Application no: H16/0501/93

Description: Demolition and rebuild
 single retail unit

Location: 5 Hall Place
 Spalding

ACKNOWLEDGEMENT OF WITHDRAWAL

Drawing No.
1158/P7

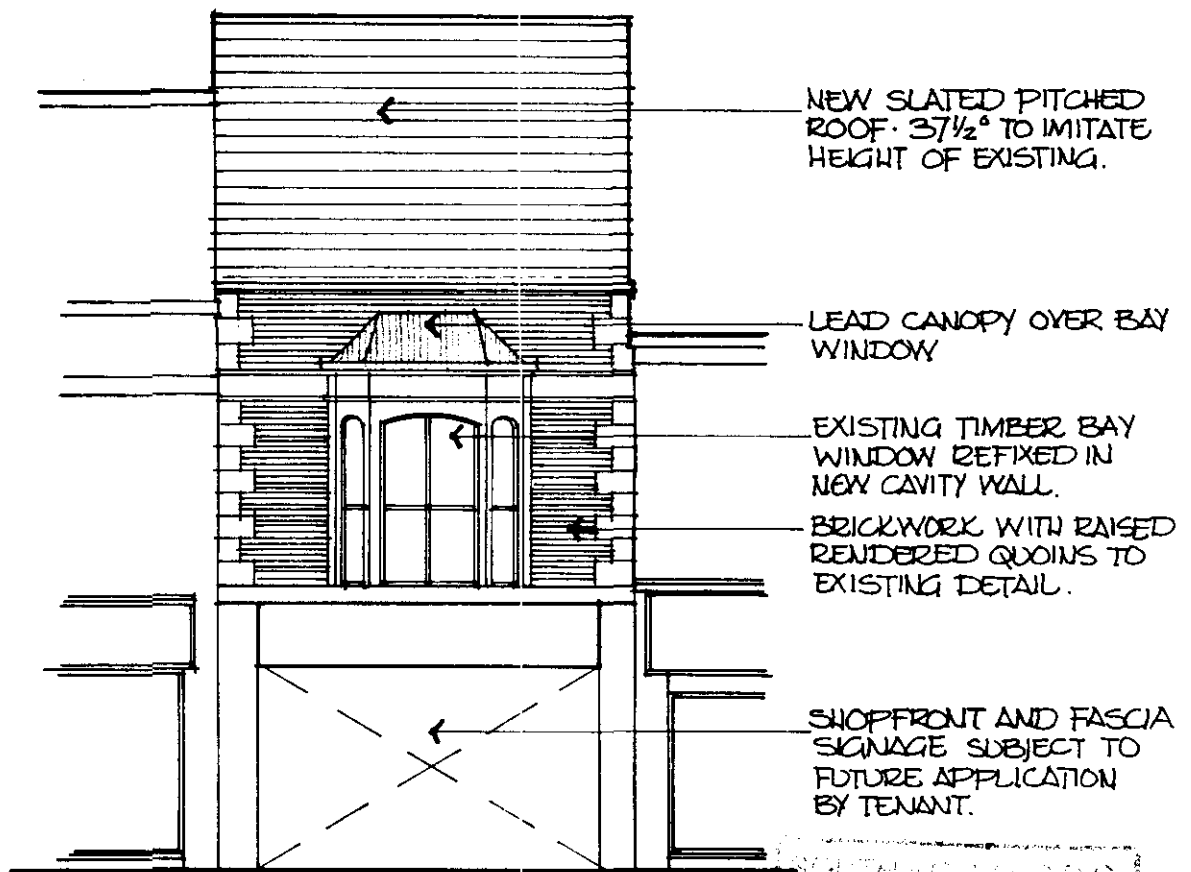
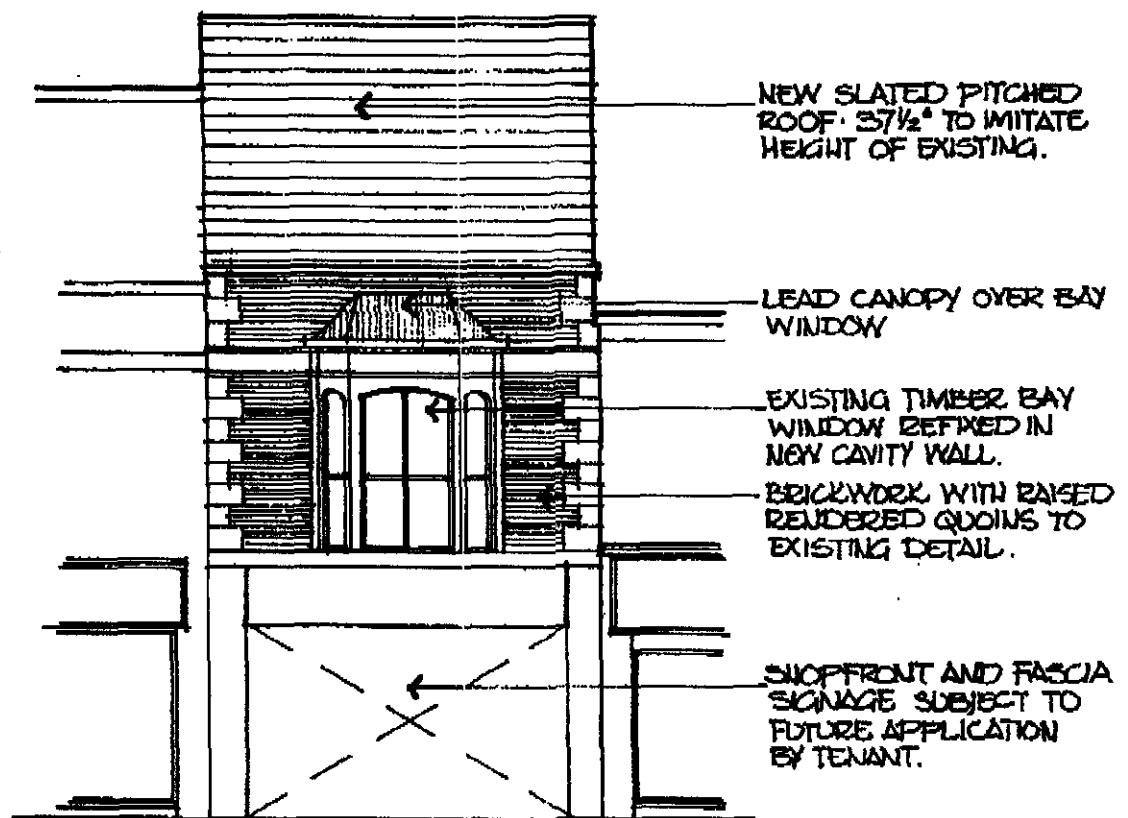
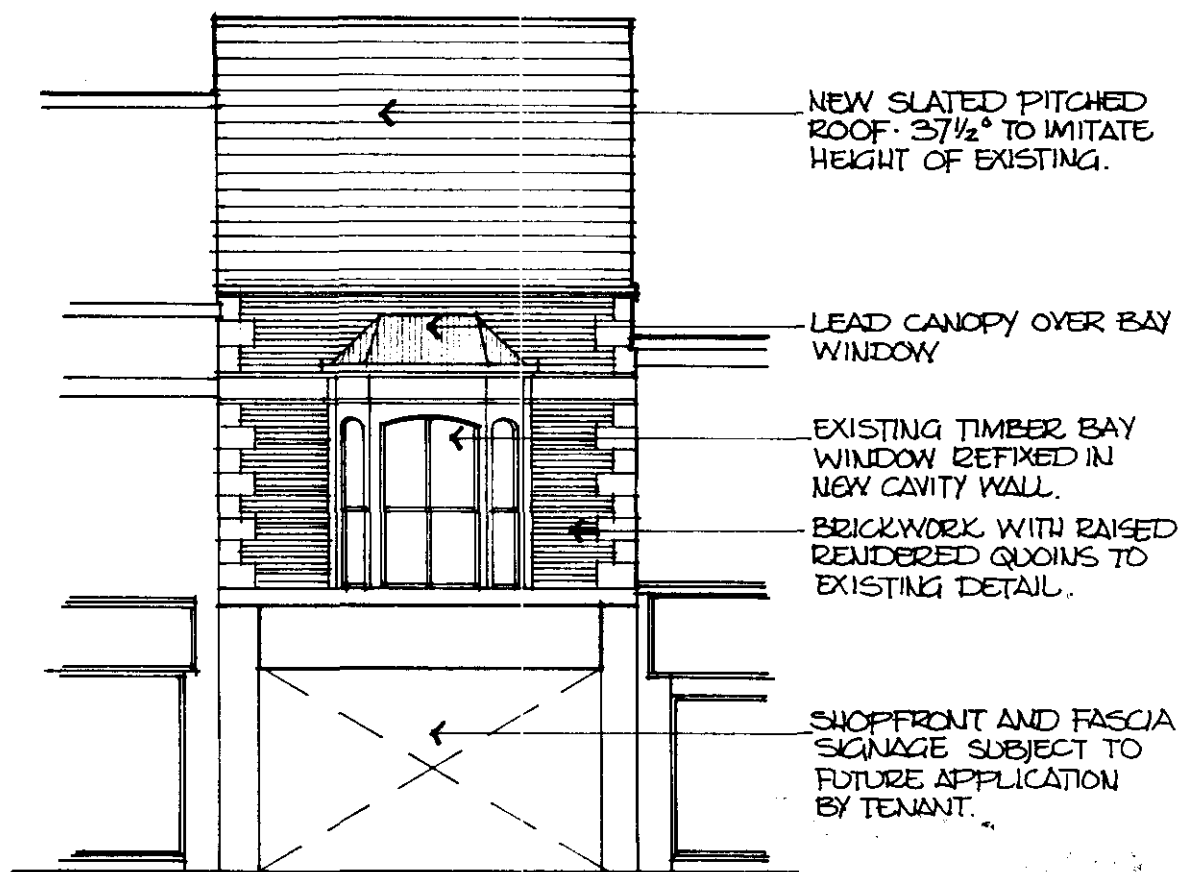
- 2 Property occupied by the Nationwide Building Society, was re-built in 1986, when there was disappointment that the building was not as good as envisaged.
- 3 The submitted plans show a building which has lost all its detail in comparison to what is there at present. The bay window is much "thinner" in construction and the quoin details and detailing at the gutter has been removed. In addition, an existing dormer window will not be replaced. The applicants are aware that we are concerned over the proposed elevation and have submitted an amended plan which shows that the existing timber bay window will be re-fixed and that there will be rendered quoin details as existing. However, the dormer window and eaves detailing are still omitted. This is an improvement but still unsatisfactory.

I refer to the above planning application and to the submission of your amended front elevation received on 13 July, 1993.

It is my opinion that these represent an improvement on what was originally submitted but I am still concerned about the loss of the dormer window in the roof and the dentilated eaves detailing. I also consider that these amendments cannot be accepted as an amendment to the original planning application.

I therefore write to suggest that you consider withdrawing the current proposal and resubmitting amended details as soon as possible, subsequent to a meeting between the Council and yourselves and the Council's Consultant Architect. I intend to take the two proposals currently submitted to the 4 August, 1993 Planning Committee and should you wish to withdraw the two applications, I will require a letter stating such before that date.

HALL PLACE ELEVATION (as proposed)

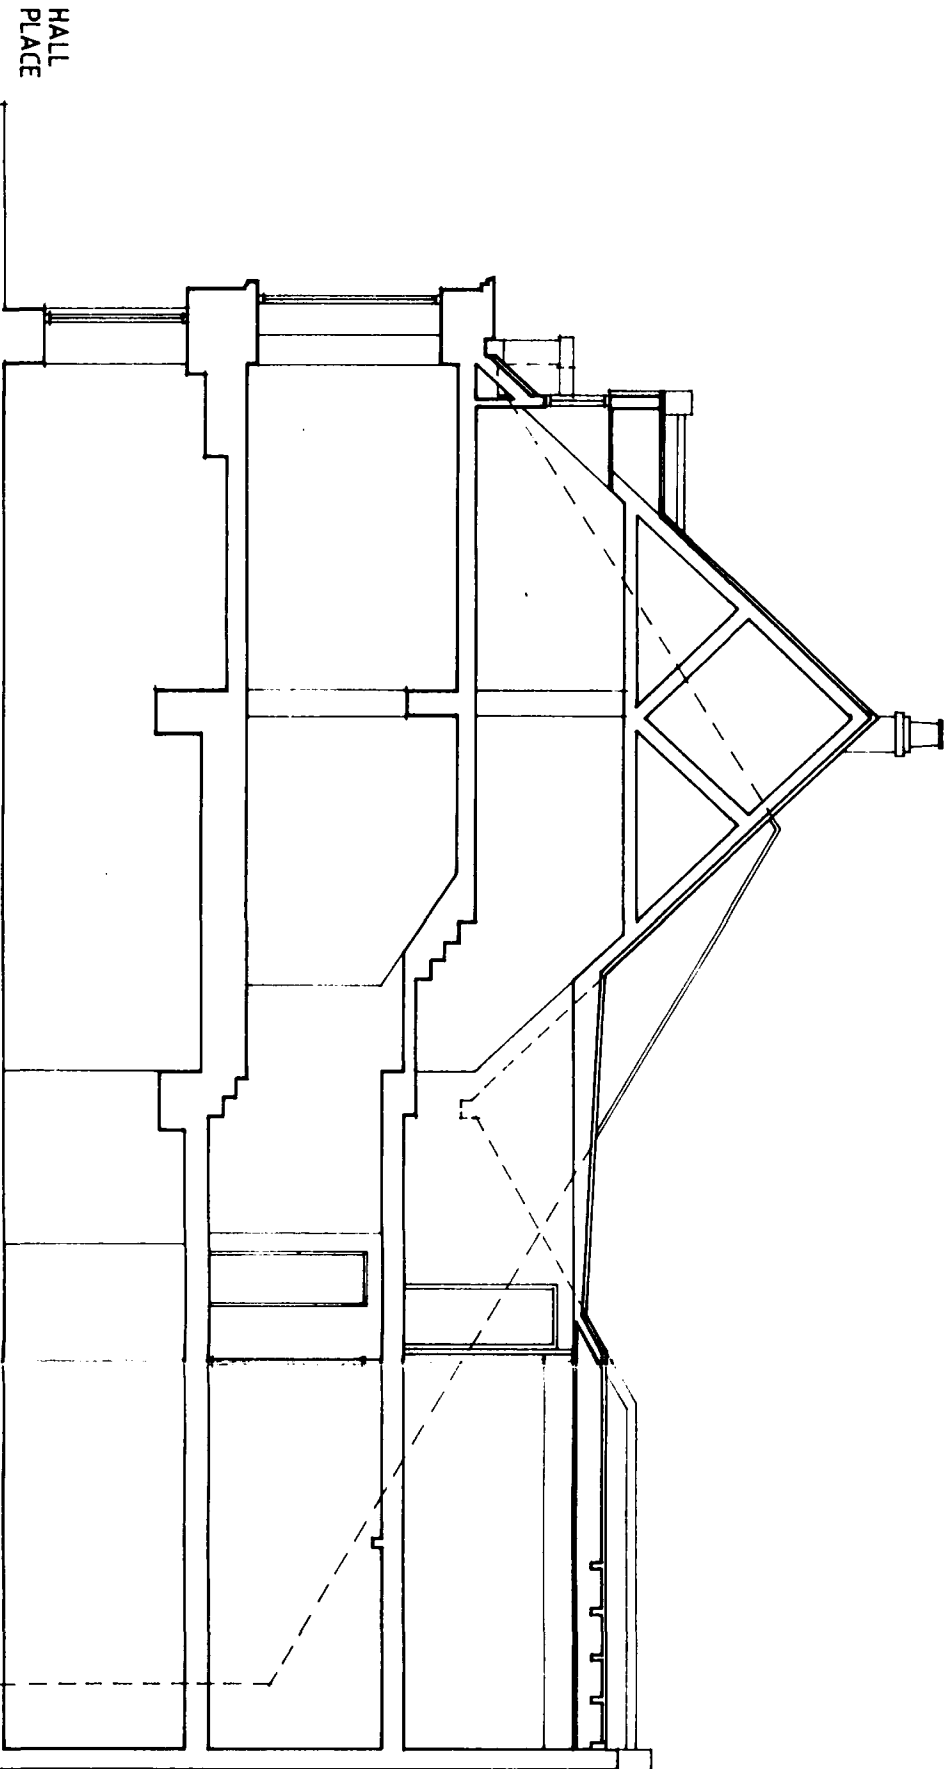
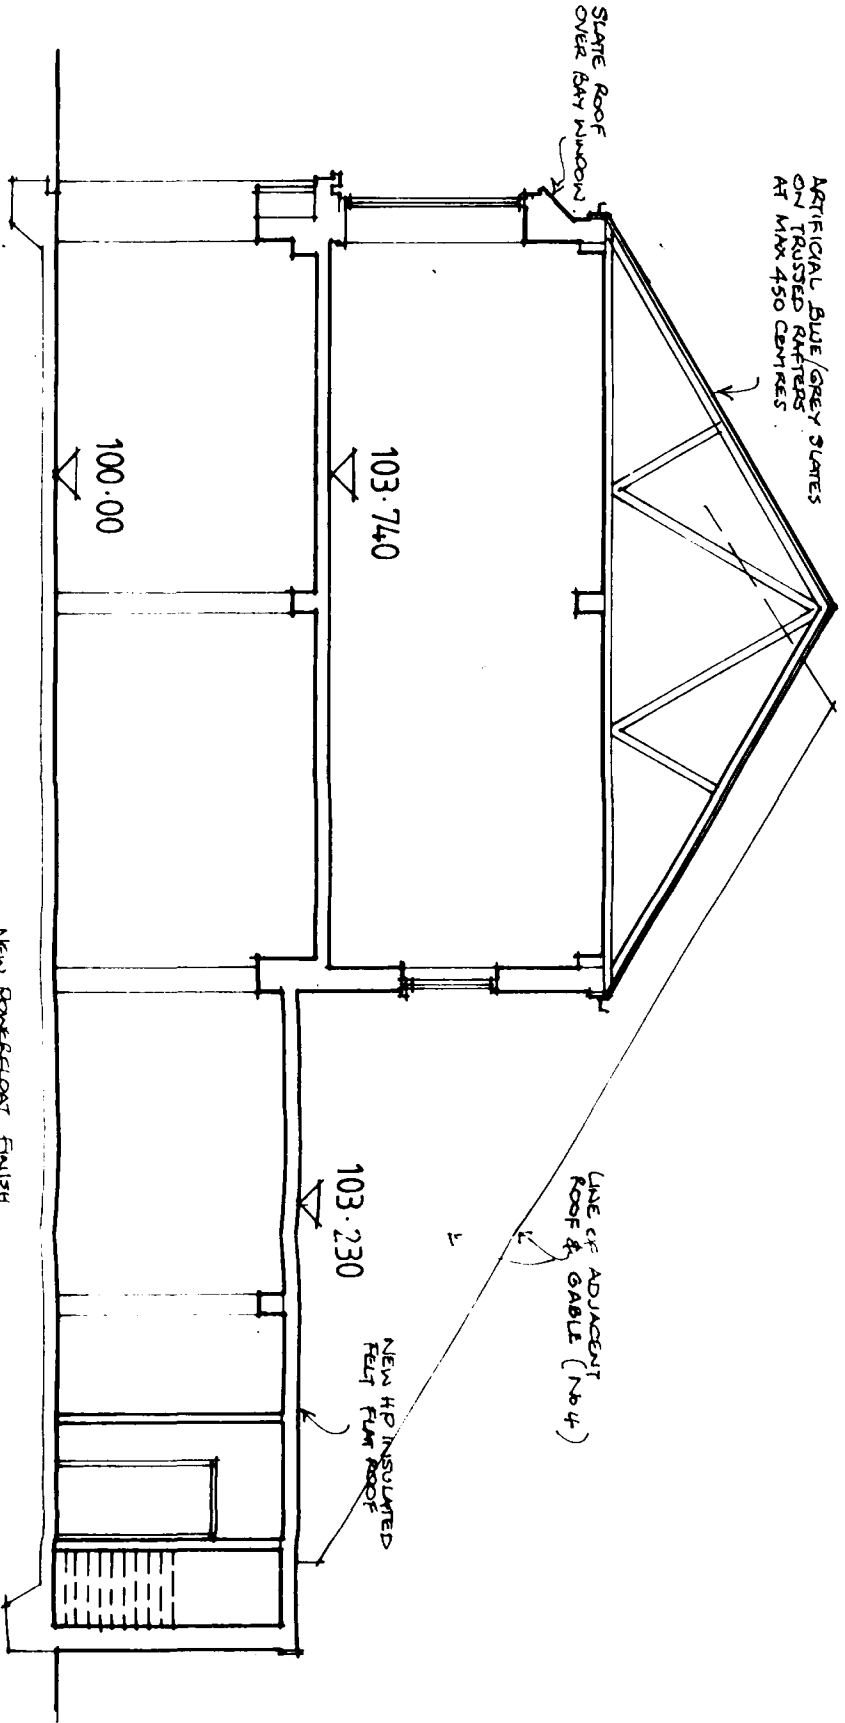
- A Refuse planning permission and Conservation Area Consent.
- 1 In the opinion of the Local Planning Authority, the demolition of the existing building and its replacement by the proposed building will result in loss of architectural detail and interests to the street scene for this part of the Spalding Conservation Area. This will result in a loss of character to this part of Spalding Conservation Area, which the Local Planning Authority has a duty to preserve.
- B The Planning Committee confirm that any redevelopment of this site must incorporate either the retention of the existing front elevation and dormer or a facsimile of the existing front elevation and dormer.
-

- Occupies prominent place in Conservation Area.
- Building appears to be late Nineteenth Century but may be enshrining an earlier structure.
- Painted brick with chamfered quoins, an attractive canted first floor bay, dentillated eaves and a small dormer in steeply pitched roof.
- Building with its pleasant detail adds interest to street and steep roof pitch adds variety.
- Clearly in need of maintenance, no evidence from front facade that condition is so bad that there is no other option than to re-build.
- Proposed re-build is thin imitation of what went before without the richness of detailing. In my view, no compensation for building which it is replacing and I cannot recommend that consent be given.
- This replacement building does not offer additional enhancement, nor does it preserve character of Conservation Area.
